Re: Final Environmental Assessment/Negative Declaration
Pedestrian Walkway and Related Improvements
Sheraton Resort
TMK: 2-8-2-16:3, Poipu, Kauai

FINAL ENVIRONMENTAL ASSESSMENT

CONSTRUCTION OF A PEDESTRIAN WALKWAY
Sheraton Kauai Hotel
Koloa, Kauai

APPENDIX A
COMMENT LETTERS AND RESPONSES

FIGURE-3

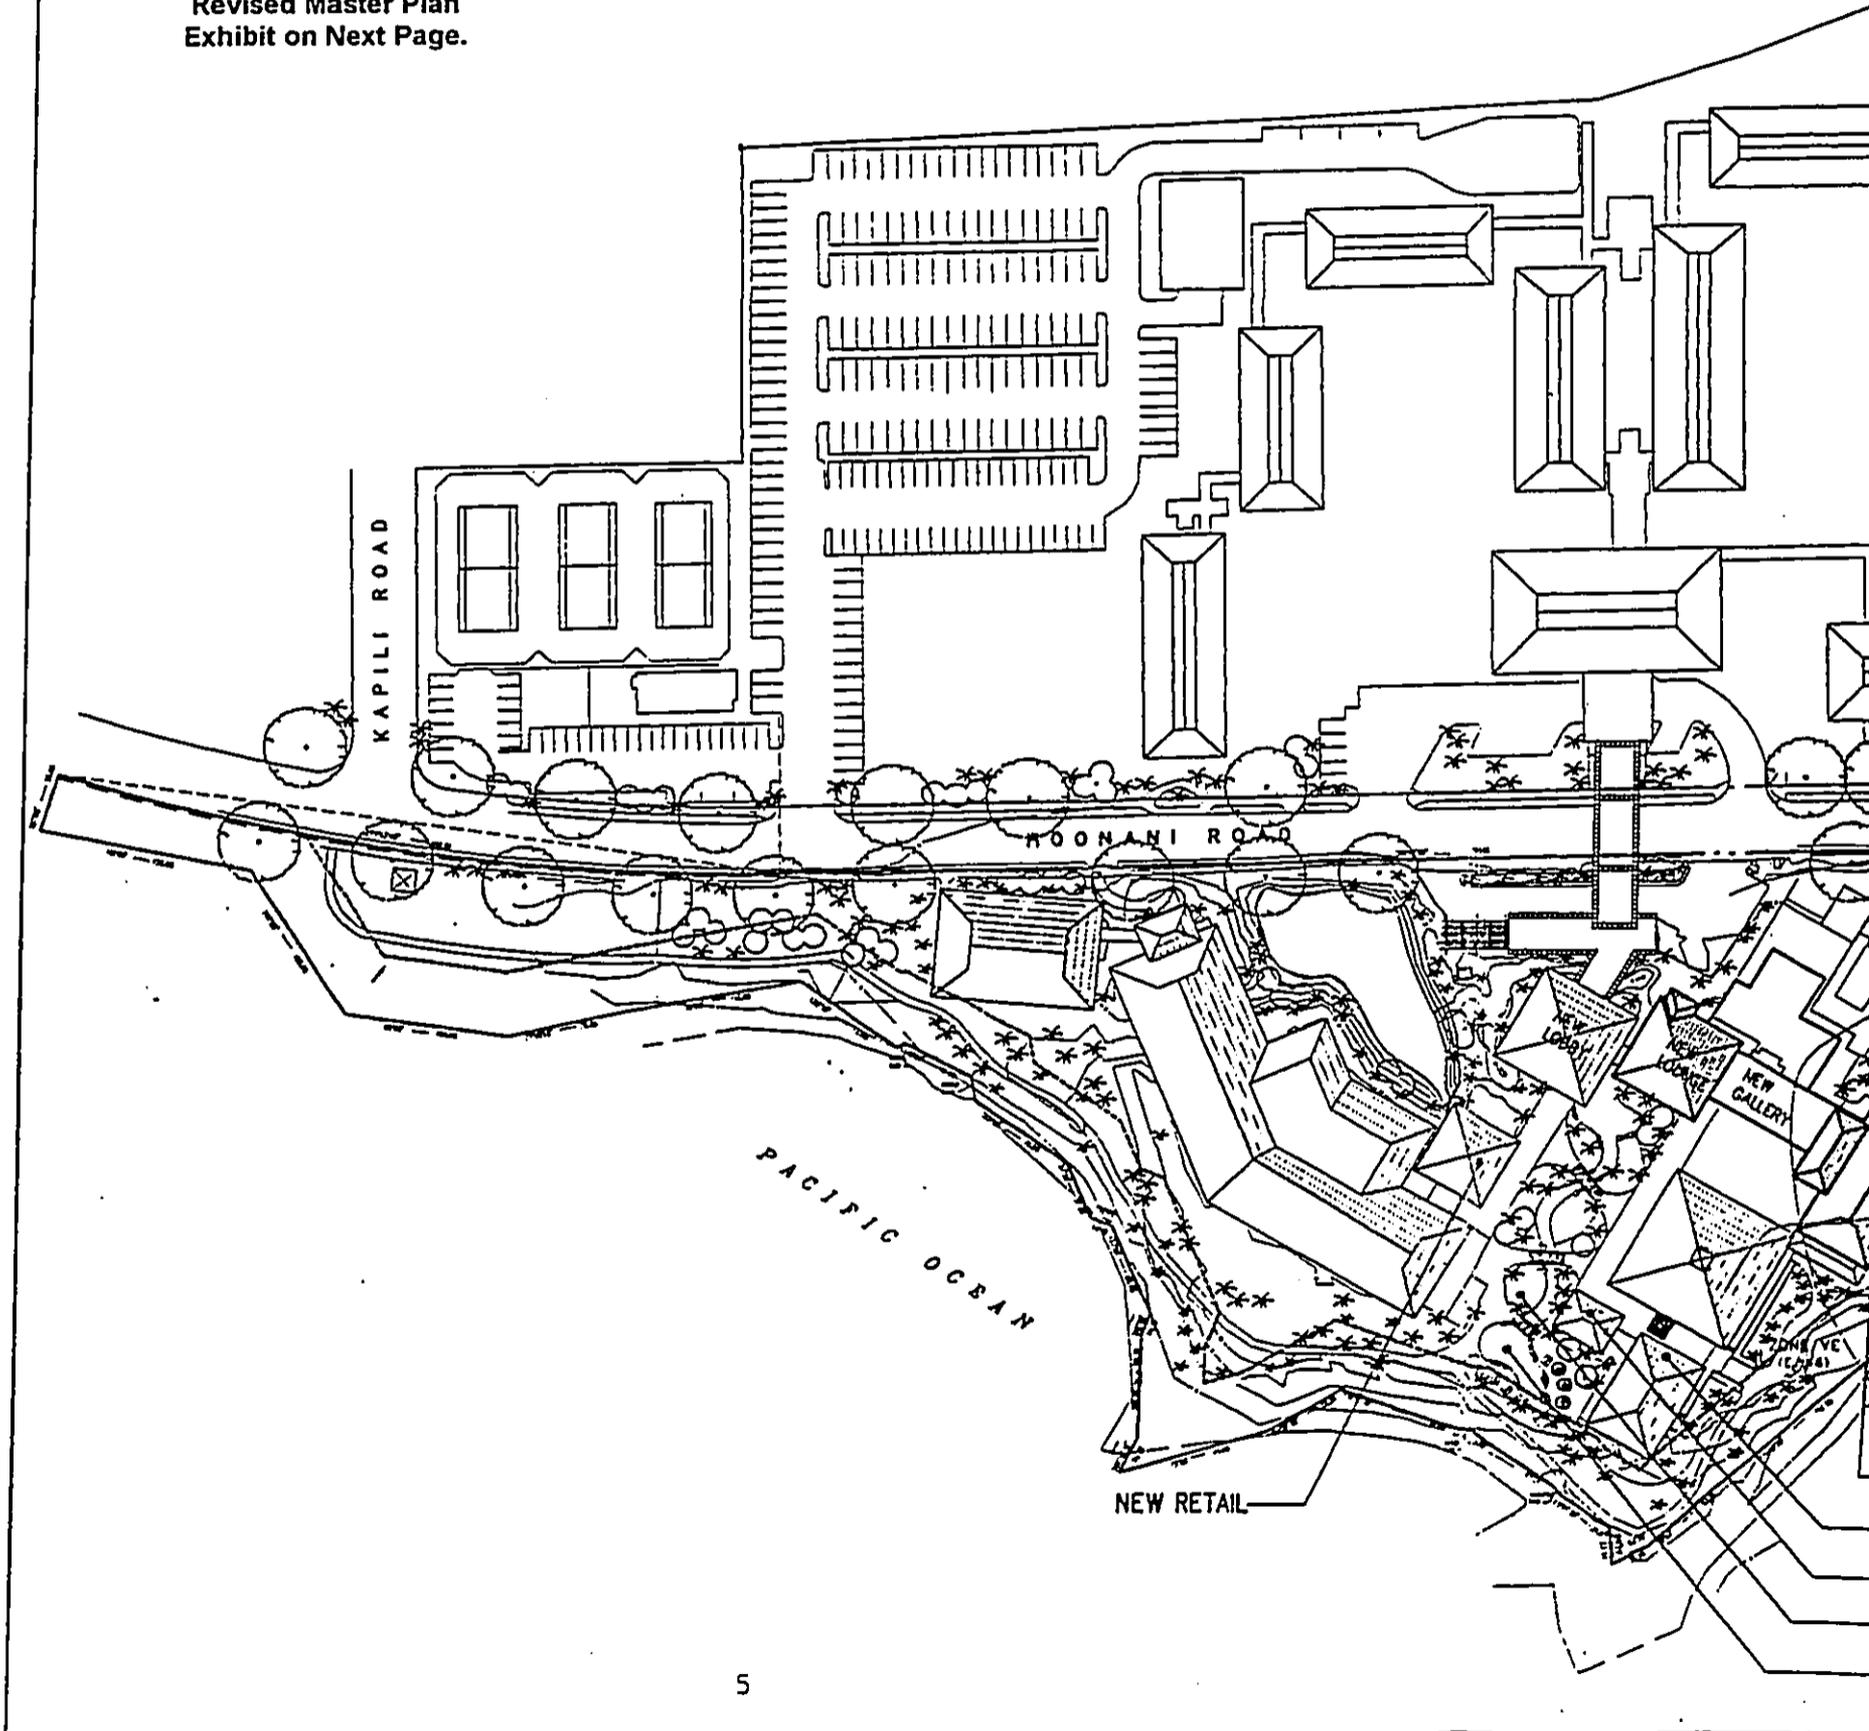
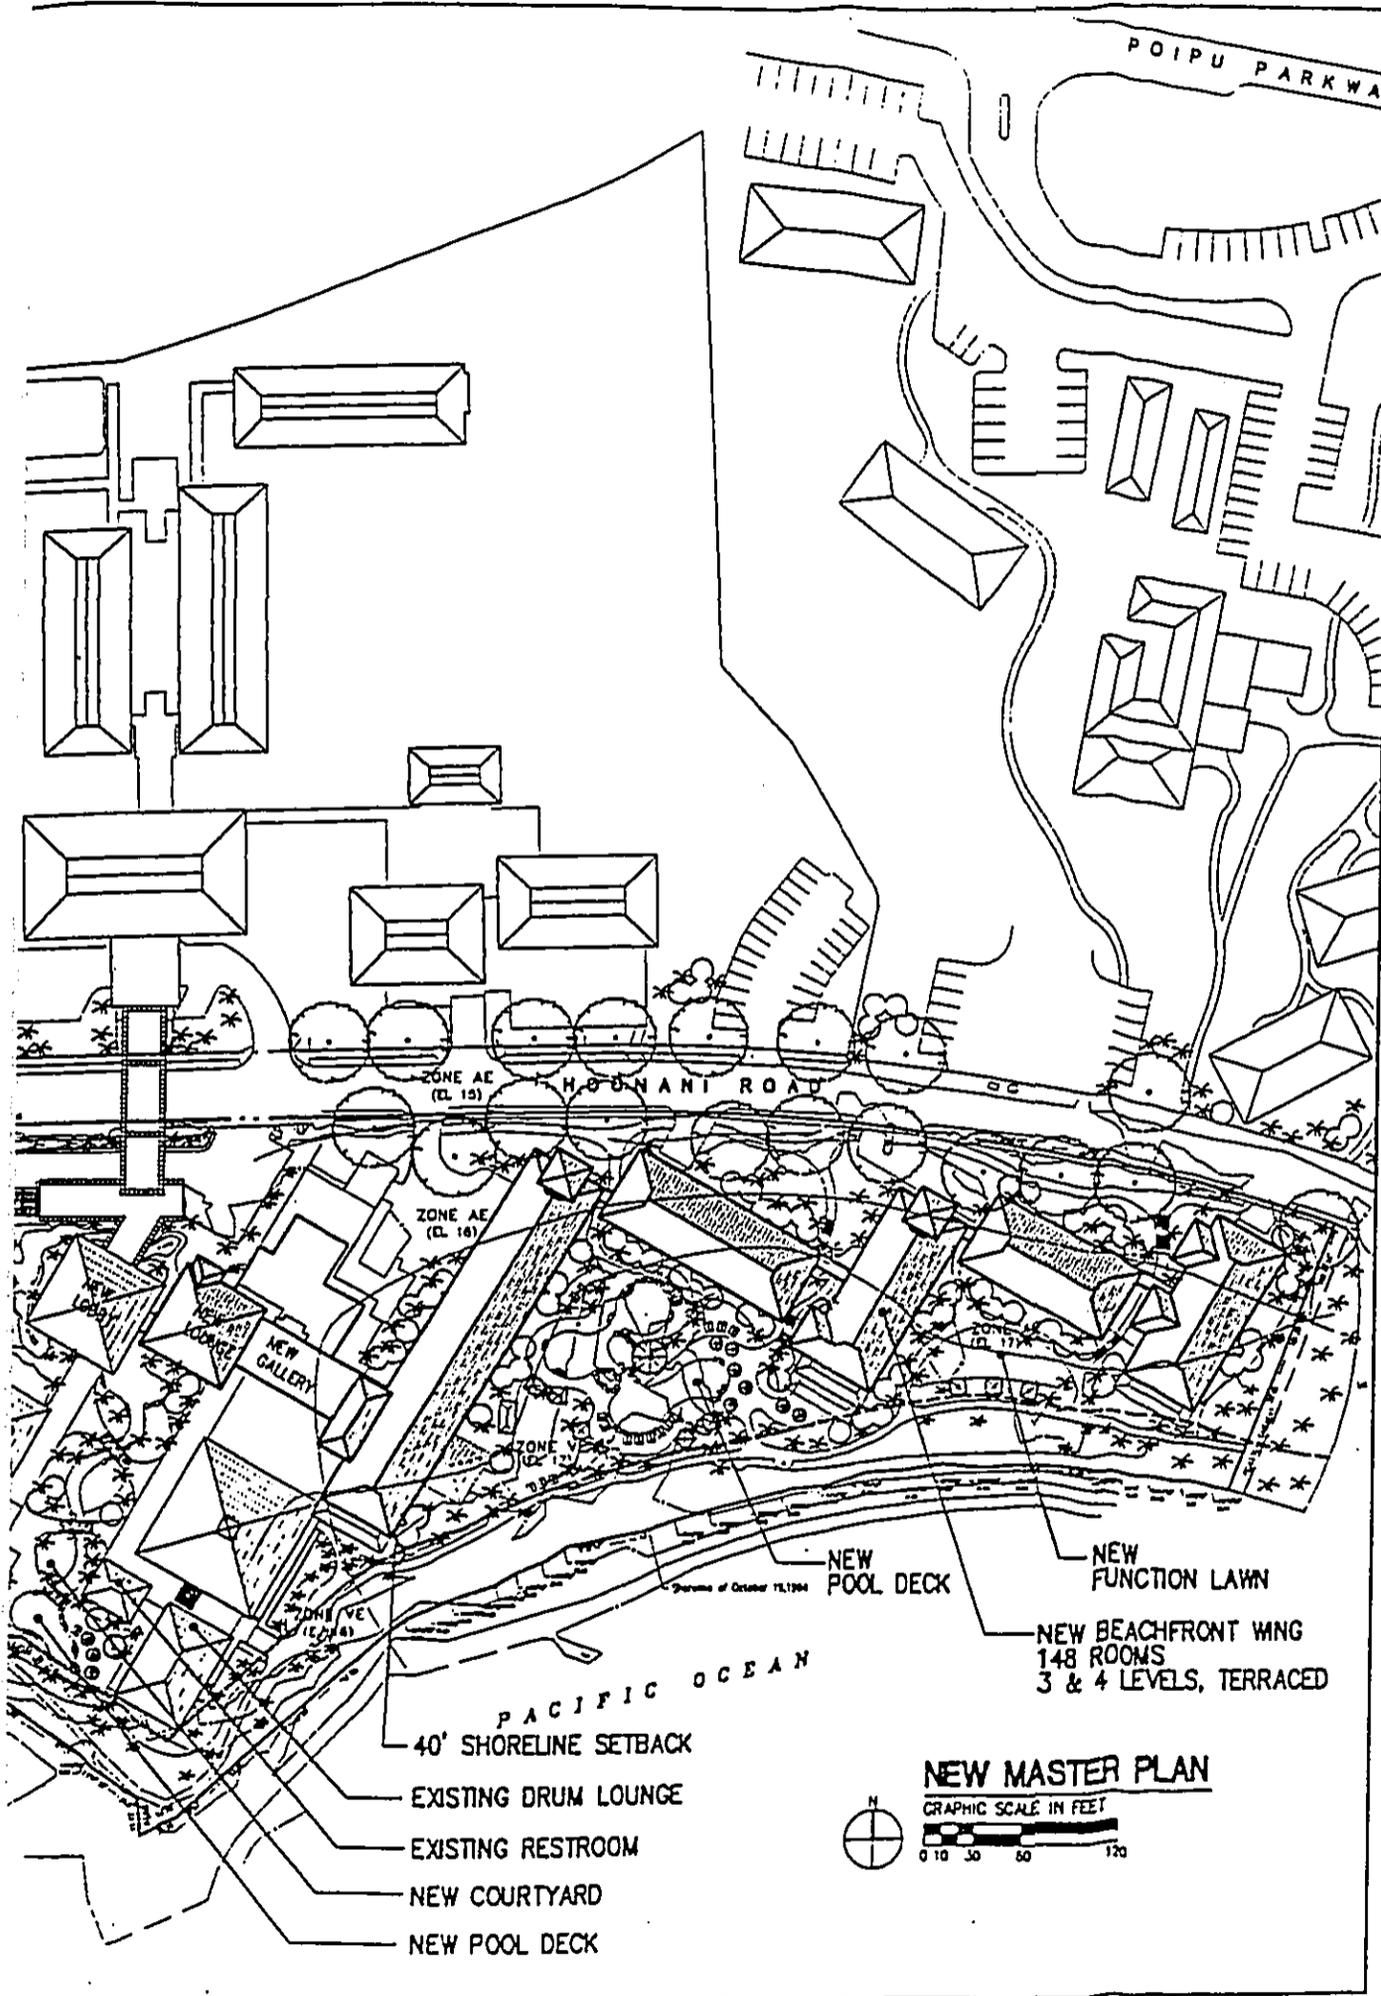
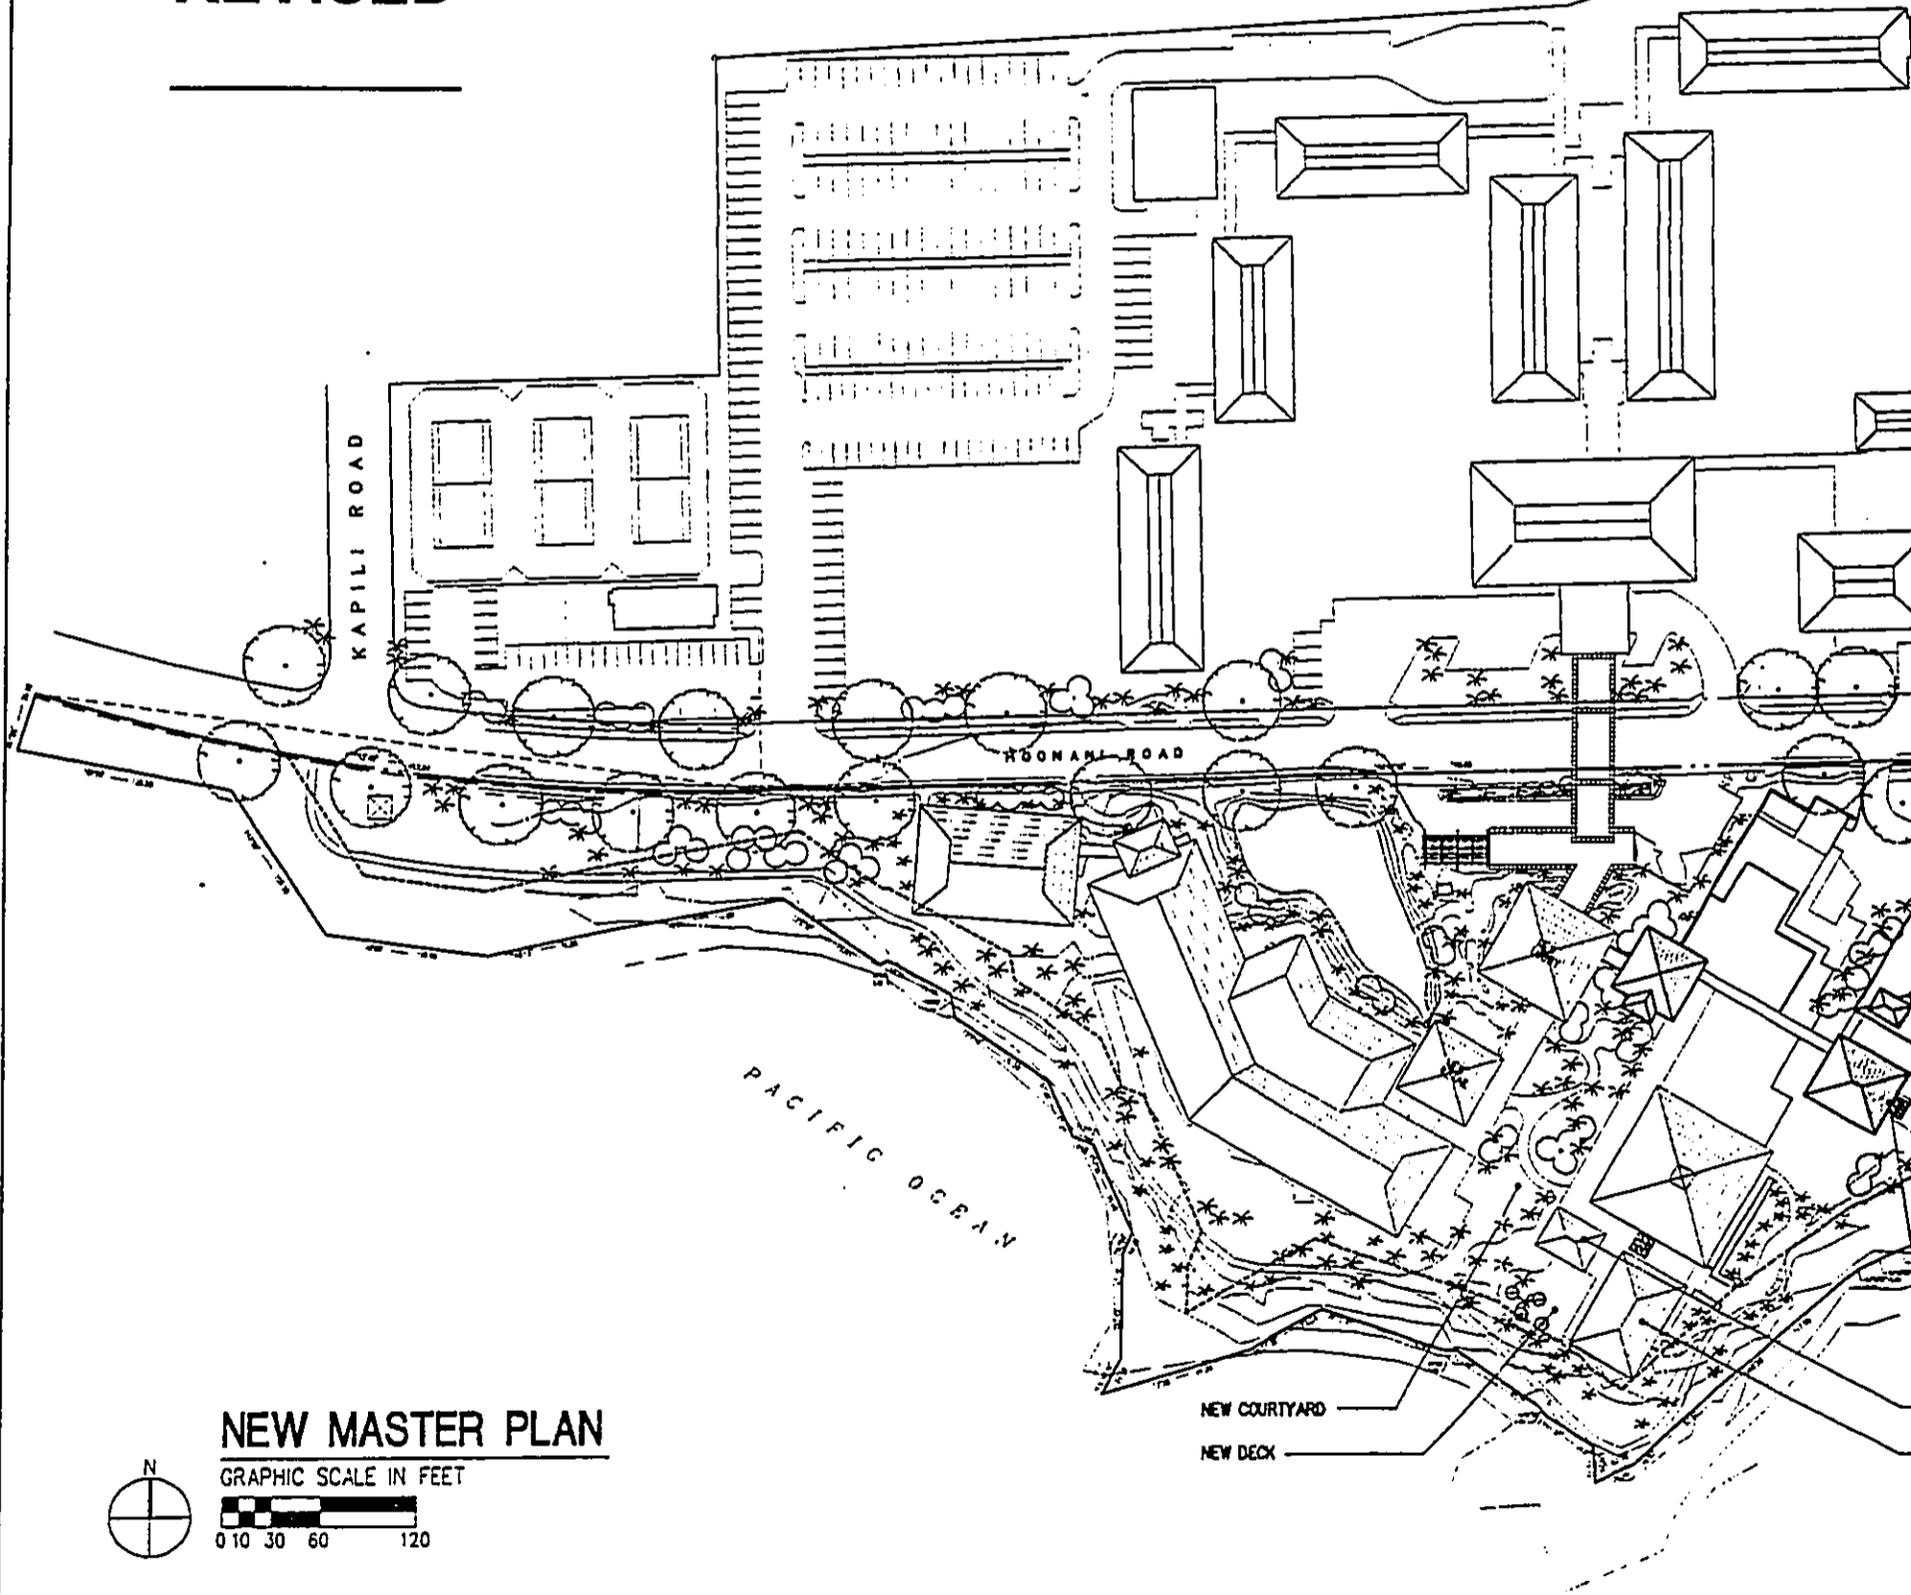
While the Sierra Club enthusiastically supports public access along the shoreline, it may be possible to provide such access without a hardened structure that impacts on beach processes. Alternatively, such a walkway should be placed further mauka to protect beach resources.

- B. The Office notes that the project's master plan as illustrated in Figure 3 shows new structures on site at the Sheraton Kauai such as a new lobby, lounge, gallery, new beachfront wing with 148 rooms, new pool deck and new function lawn. Section 11-200-7, Hawaii Administrative Rules requires that a group of actions proposed by an applicant shall be treated as a single action the component actions are phases or increments of a larger total undertaking. Please discuss the relationship of the proposed walkway as an integral part of these master-planned improvements and the direct, indirect and cumulative impact of these master-planned improvements.

In discussions with the Planning Department, Obayashi has suggested moving the walkway inland away from Poipu Beach and locating it outside the shoreline setback area. This alternative is now possible because Obayashi has voluntarily reduced the density of the oceanfront wing from 134 to 90 rooms and the number of proposed structures from five to four thus freeing ground level space for accessory facilities.

The walkway design criteria and a revised site plan depicting the new walkway alignment shall be included in the Final Environmental Assessment.

- e) See Item 1.
- f) Photos will be submitted to the Planning Department.
- g) In discussions with the Planning Department, Obayashi has suggested moving the walkway inland away from Poipu Beach and locating it outside the shoreline setback area. This alternative is now possible because Obayashi has voluntarily reduced the density of the oceanfront wing from 134 to 90 rooms and the number of proposed structures from five to four thus freeing ground level space for accessory facilities. A revised site plan shall be included in the Final Environmental Assessment.
